BULLETIN: CA-SB-19-E-72-61  
DATE: 1/28/72  
PAGE: 1 OF: 3

## SERVICE BULLETIN

**19EA OIL PUMP CAPACITY INCREASE**

Fig. 1. Oil Pump and Motor Assembly

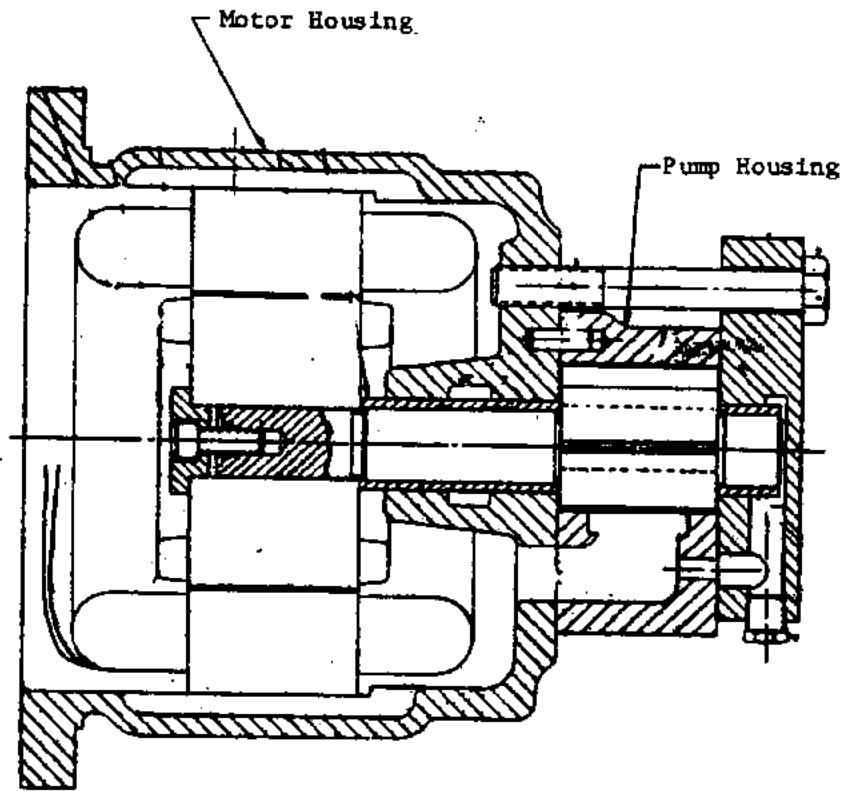
The 1 hp, 19EA5 oil pump will be installed on the above 19EA4 machines in place of the 1/2 hp pump to increase the pumping capacity of the 19EA4 lubrication system. This conversion should be made in the field only if problems are experienced with the existing pump.

Mechanically, the one horsepower pump and motor package (Fig. 1) is directly interchangeable with the existing 1/2 hp assembly. There are differences in the motor and pump housing, but these do not affect the interchangeability of the complete package.

**CAUTION:** Use extra care when connecting the motor leads to the terminals to insure that the motor leads cannot touch the rotor.

Fig. 2. Motor Connection Diagrams

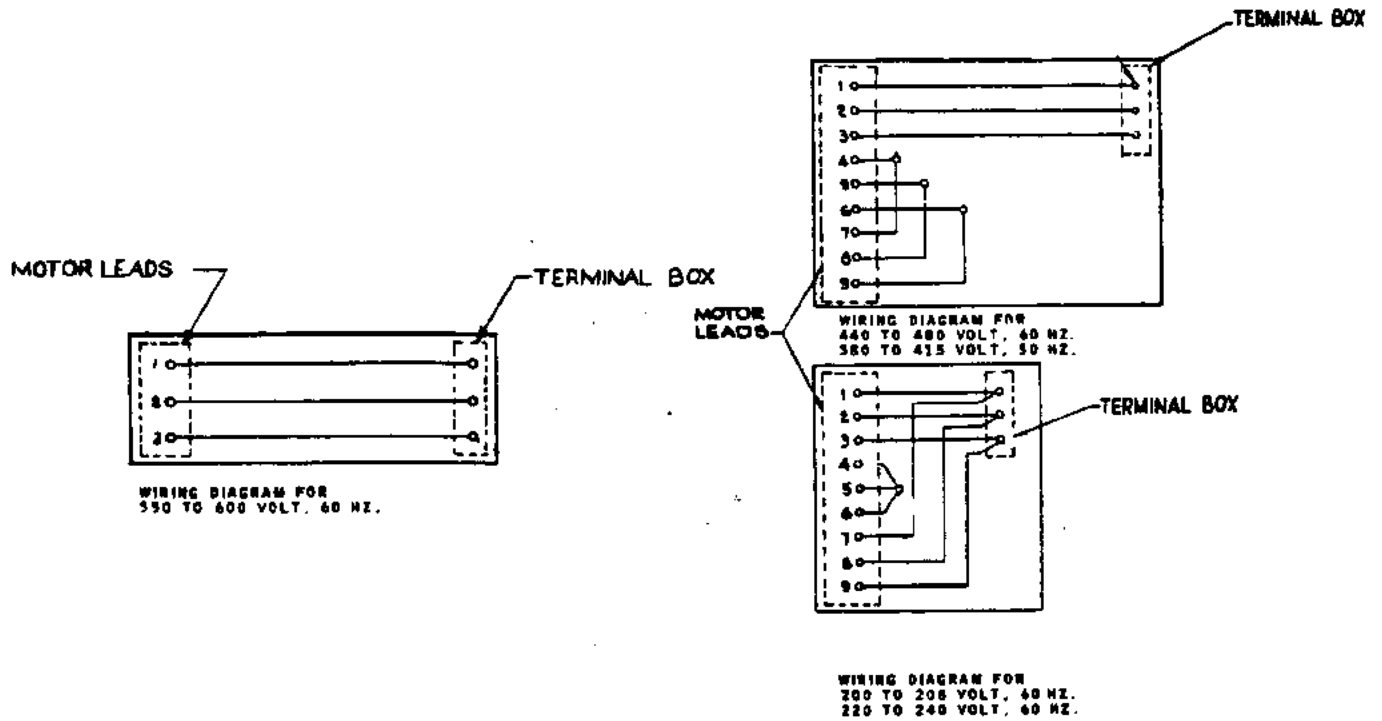
PSD will no longer stock the obsolete 1/2 hp pump. They will ship 1 hp pumps wired for 440 or 550 v. The 440 V motor can be reconnected easily for 220V as shown in Fig. 2.
